## **SHADY GROVE SUBDIVISION, RESUBDIVISION OF LOTS 10 & 11**

APPLICATION NUMBER 6 DATE May 1, 2014  
 APPLICANT Shady Grove Subdivision, Resubdivision of Lots 10 & 11  
 REQUEST Subdivision

# DETAIL SITE PLAN

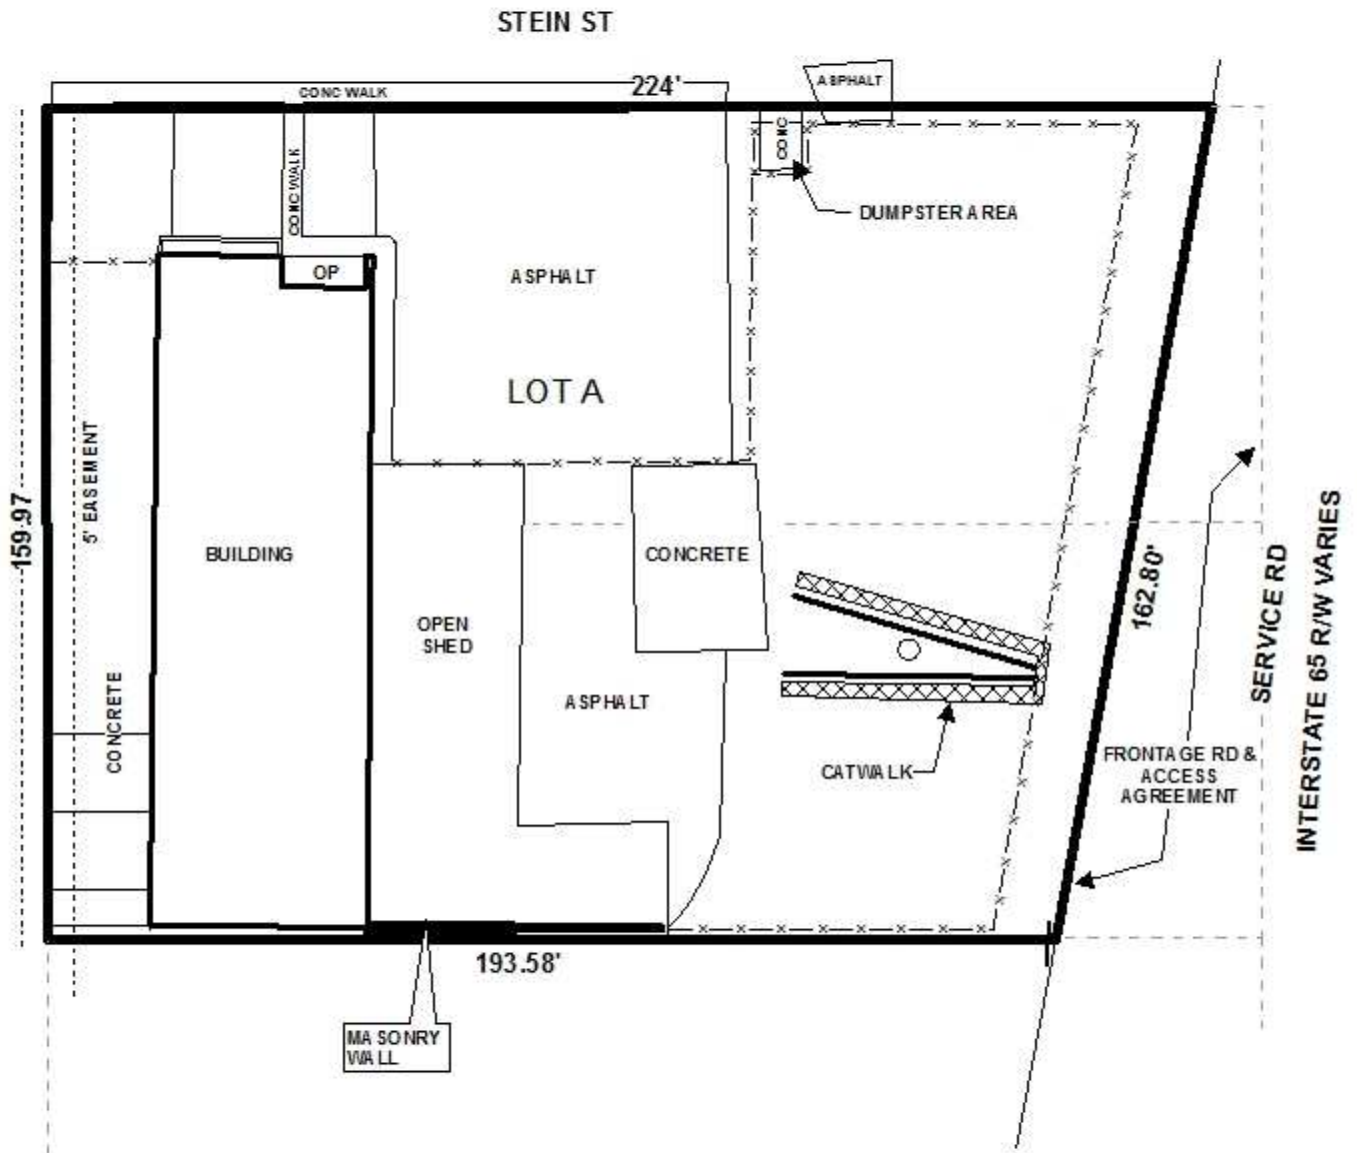
The site fronts Stein Street and West I-65 Service Road North. Stein Street is a minor street with a required 50' right-of-way, and I-65 is a component of the Major Street Plan with a planned 300' right-of-way. The preliminary plat does not indicate a right-of-way width for either. Therefore, the plat should be revised to indicate the minimum right-of-way width from centerline for each roadway. If the Stein Street right-of-way is less than 50' from centerline, dedication would be required to provide 25' from the centerline. If the I-65 right-of-way width is less than 150' from centerline, dedication would be required to provide 150' from centerline. Also, a 25' radius curve should be dedicated at the corner of Stein Street and West I-65 Service Road North, as per Section V.B.16. of the Subdivision Regulations.

The site has two existing curb-cuts along Stein Street and should be limited to one of those two for Stein Street access. There are two existing ditch cross-overs along West I-65 Service Road North but no curb cuts. Access to West I-65 Service Road North should be limited to one curb cut with the size, location and design to be approved by Traffic Engineering and ALDOT, and conform to AASHTO standards.

There is no 25' minimum building setback line indicated on the preliminary plat. The plat should be revised to illustrate a 25' minimum building setback line along all street frontages as measured from any required dedications.

The lot size is not indicated on the preliminary plat; therefore the plat should be revised to label the lot with its size in square feet and acres, after any required dedications, or a table should be furnished on the Final Plat providing the same information.

It should be noted that the site abuts residential zoning and use along the West side. A 6' high wooden privacy fence, in compliance with Section V.D.8. of the Subdivision Regulations, should be installed and illustrated on the plat prior to signing the Final Plat. And the preliminary plat indicates an open shed on the West side of the building which is within the required 10' residential buffer strip and also within a recorded 5' sewer line easement. Therefore, the partial removal of the shed to 10' off the West property line will be required, with appropriate permits, prior to signing the Final Plat. A note should be required on the Final Plat stating that no structures shall be constructed within the easement.

- 1) revision of the plat to either indicate a compliant 25' right-of-way width from the centerline of Stein Street or dedication to provide 25' from the centerline of Stein Street;

- 2) revision of the plat to either indicate a compliant 150' right-of-way width from the centerline of I-65 or dedication to provide 150' from the centerline of I-65;

- 3) dedication to provide a 25' radius curve at the intersection of Stein Street and I-65 Service Road North, as per Section V.B.16. of the Subdivision Regulations;

- 4) placement of a note on the Final Plat stating that the lot is limited to one of the two existing curb cuts to Stein Street, with the size, location and design to be approved by Traffic Engineering and conform to AASHTO standards;

- 5) placement of a note on the Final Plat stating that the lot is limited to one curb cut to West I-65 Service Road North, with the size, location and design to be approved by Traffic Engineering and ALDOT and conform to AASHTO standards;

- 6) revision of the plat to illustrate a 25' minimum building setback line along all street frontages as measured from any required dedications as per Sections VII.A.1. and VII.A.2. of the Subdivision Regulations;

- 7) revision of the plat to label the lot with its size in square feet and acres, after any required dedication, or the furnishing of a table on the Final Plat providing the same information;

- 8) provision of a 6' high wooden privacy fence along the West property line where the site adjoins residential zoning and use, to be illustrated on the Final Plat prior to its signing;

- 9) at least the partial removal of the open shed on the West side of the building to at least 10' off the West property line, with appropriate permits, prior to the signing of the Final Plat;

- 10) placement of a note on the Final Plat stating that no structure shall be constructed within any easement;
- 11) placement of a note on the Final Plat stating that approval of all applicable Federal, state and local agencies is required for endangered, threatened or otherwise protected species.
